North Campus Faculty Housing Phase II  
Project No. FM110407L/986315

**Addendum No. 6**

ADDENDUM NUMBER 6  
to the  
CONSTRUCTION DOCUMENTS

**BUILDING 700A REVERSE SECTIONS**

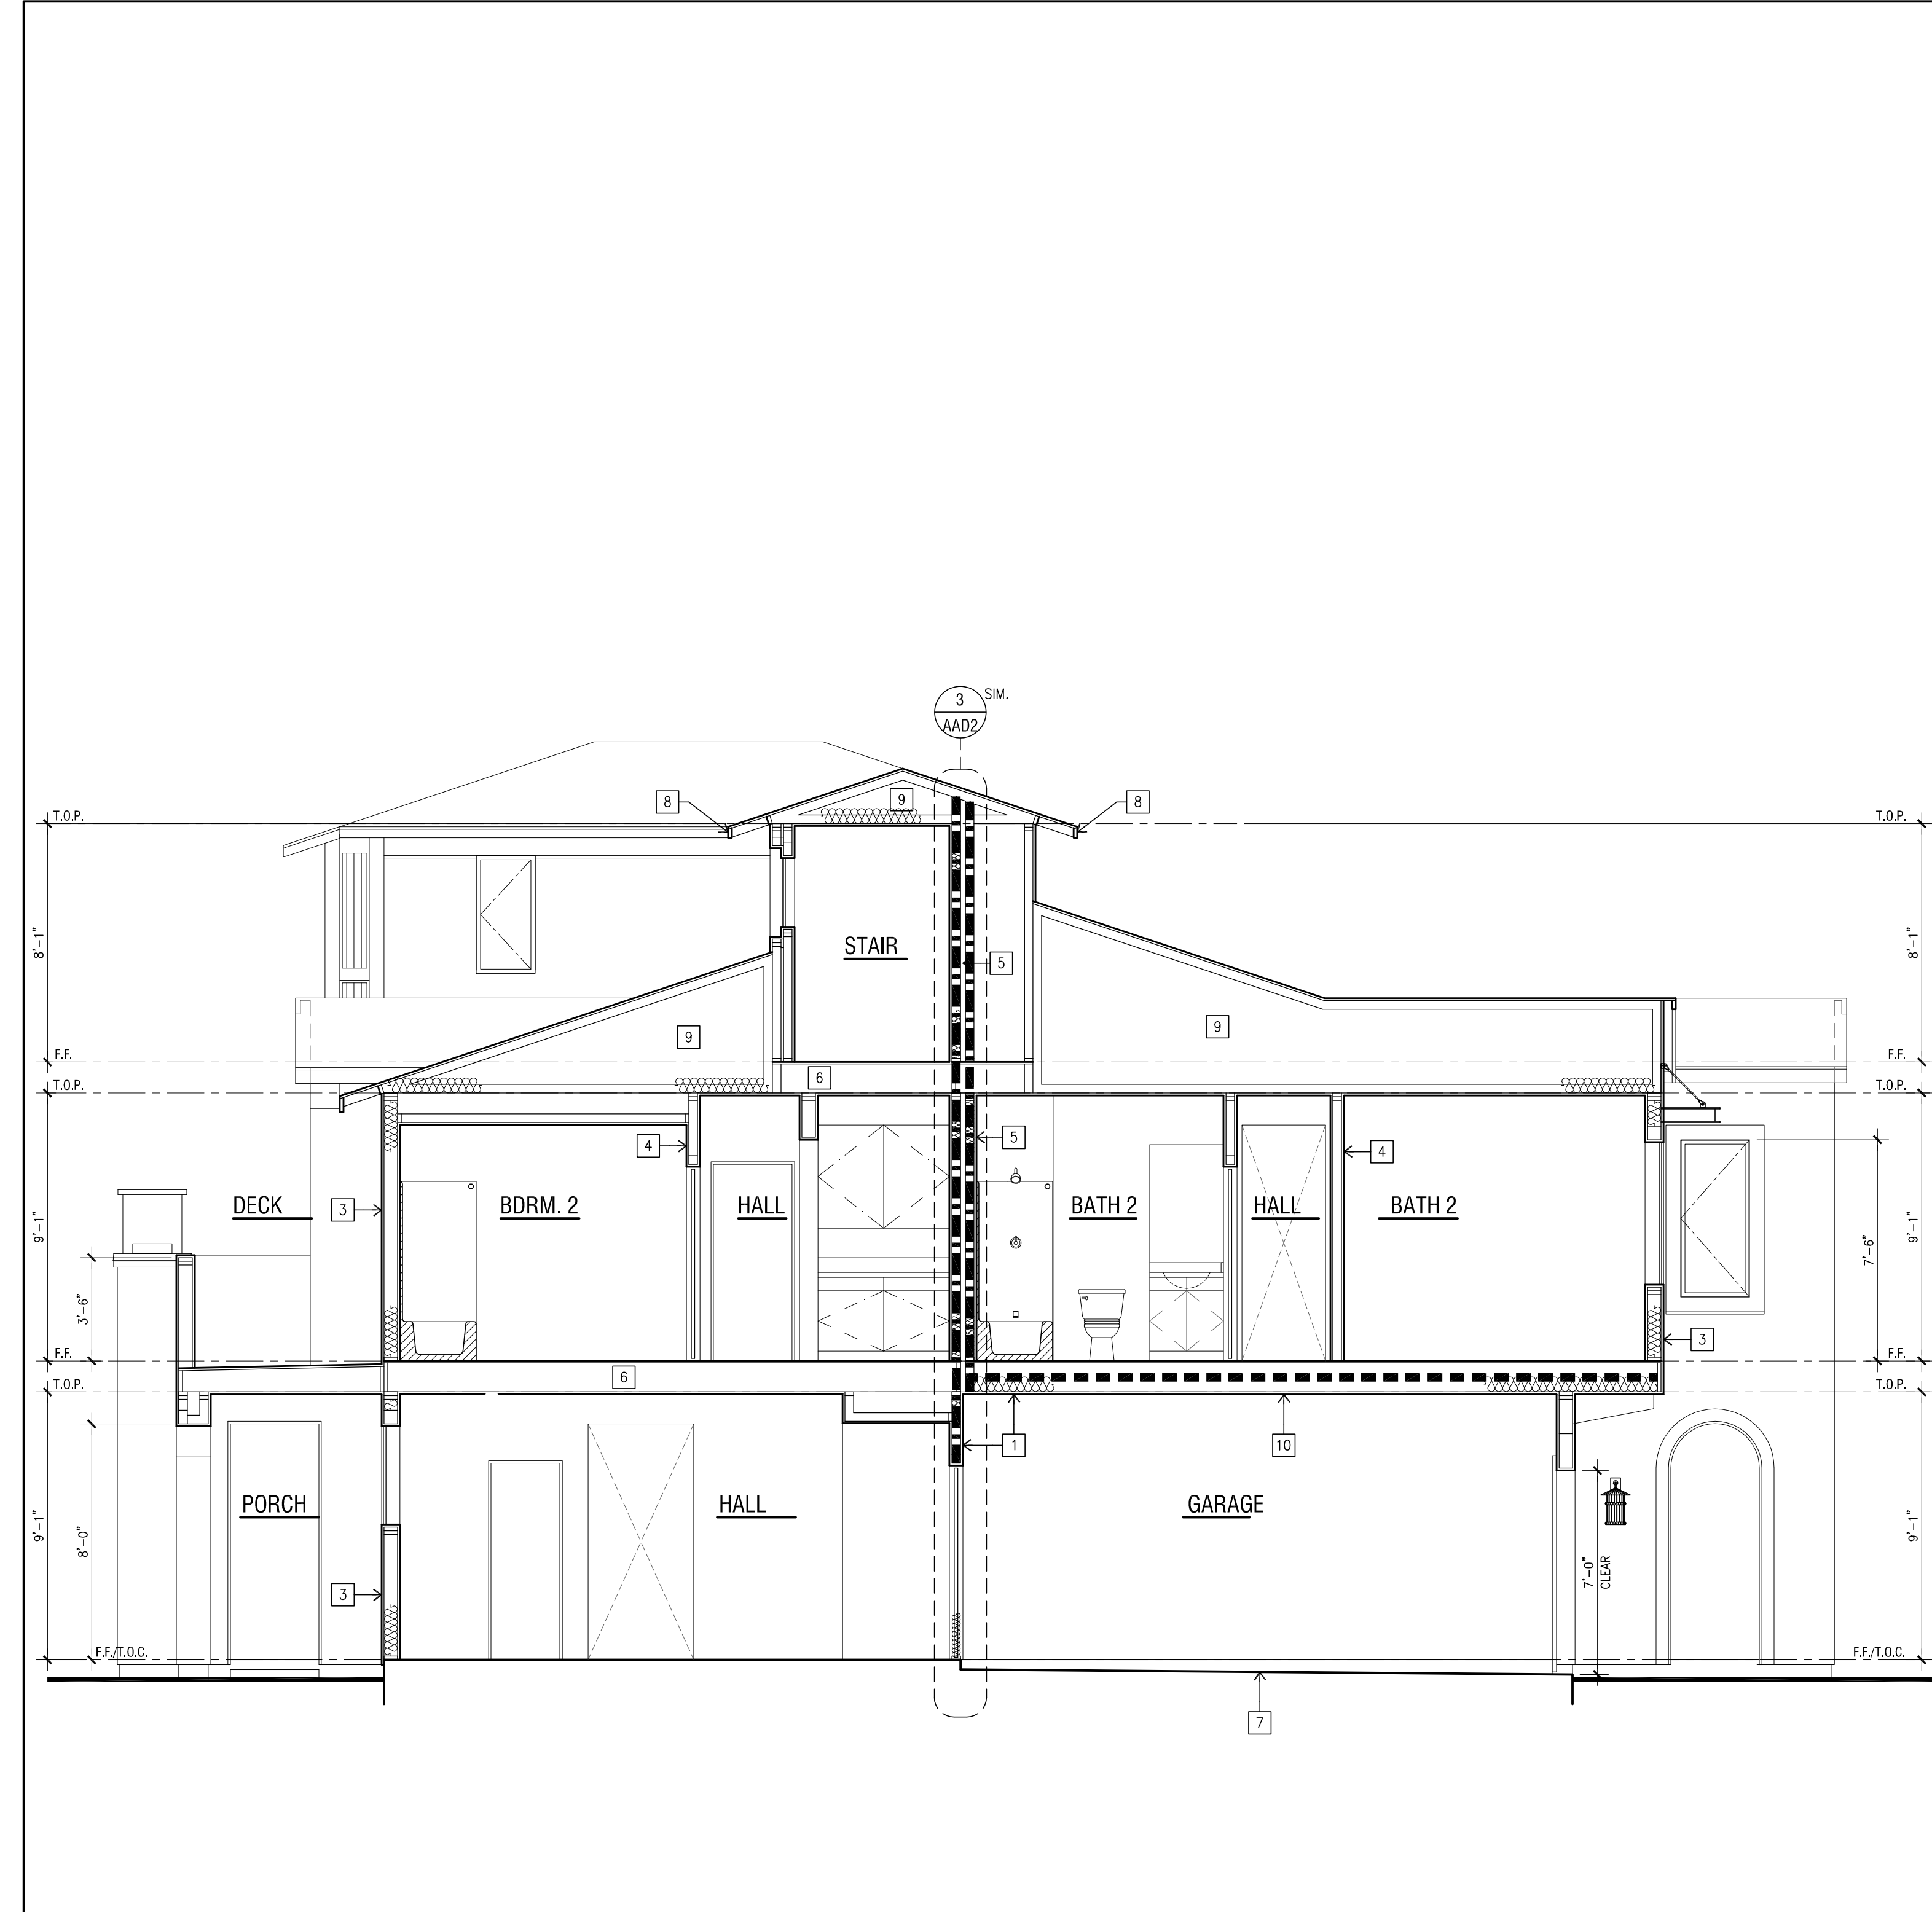
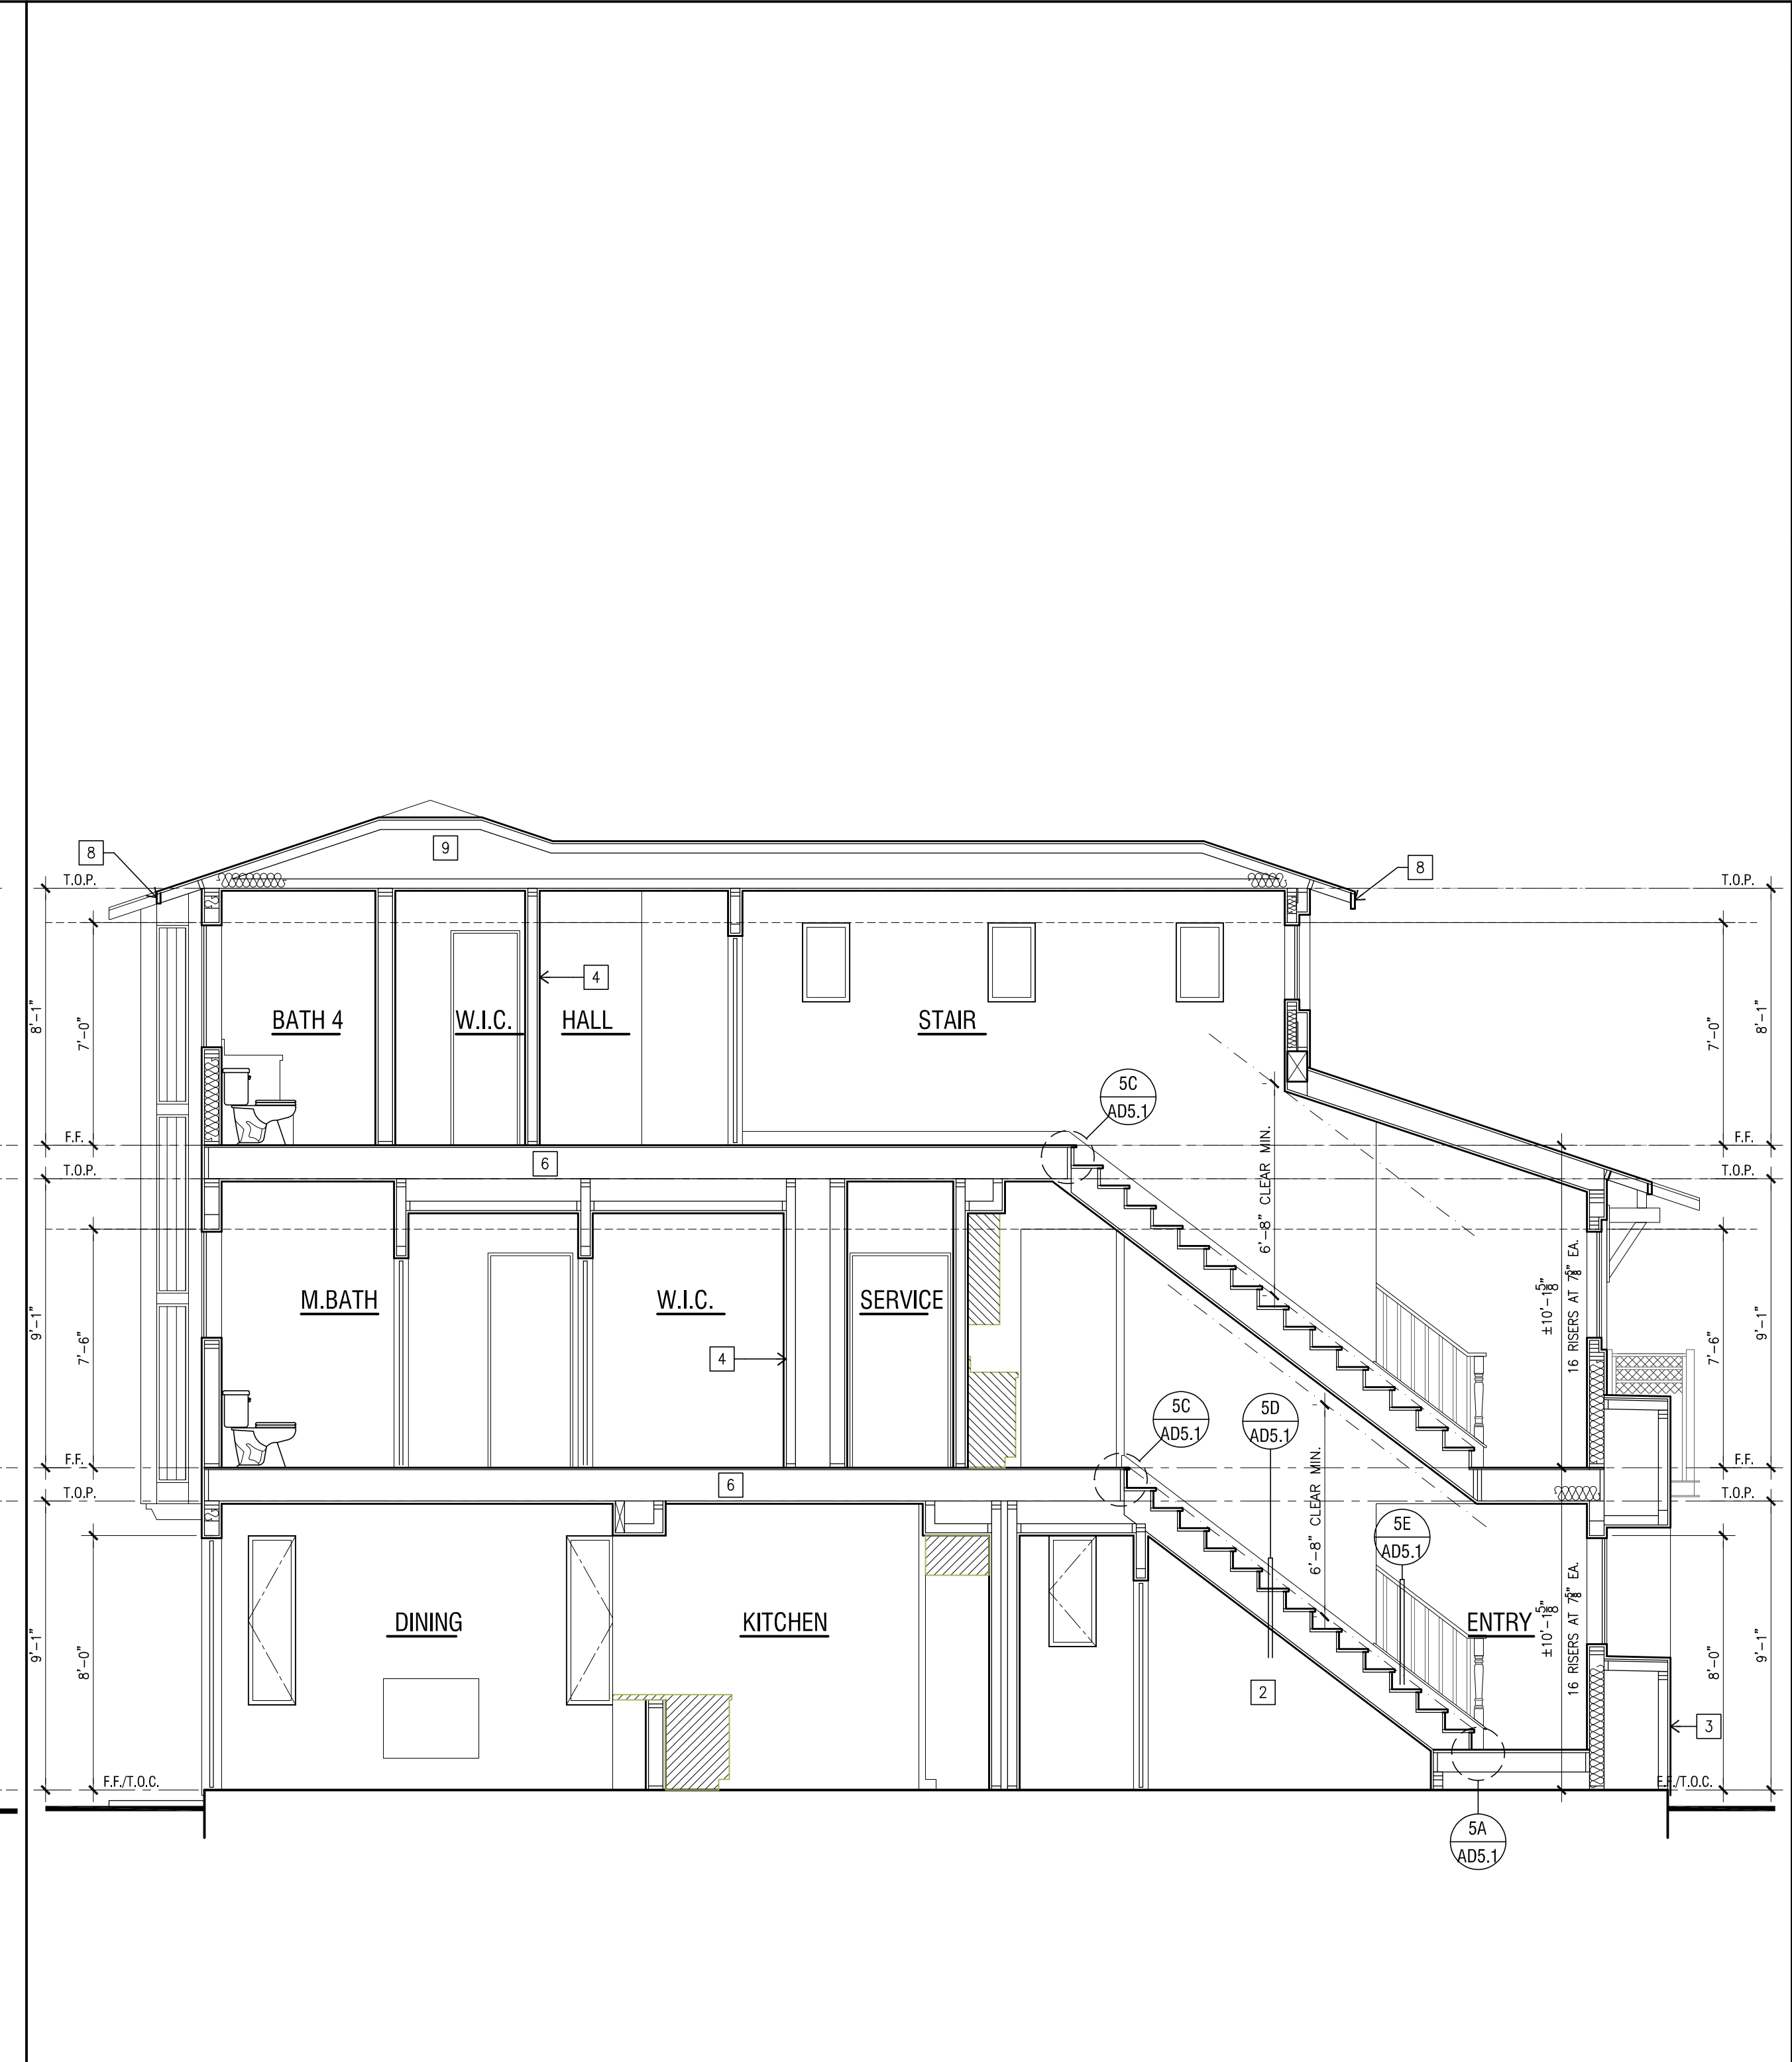
Sketch 5 of 8	Building 600A: Reverse: Sections
Sketch 6 of 8	Building 600B: Sections
Sketch 7 of 8	Building 700A: Sections
Sketch 8 of 8	Building 700A: Reverse: Sections
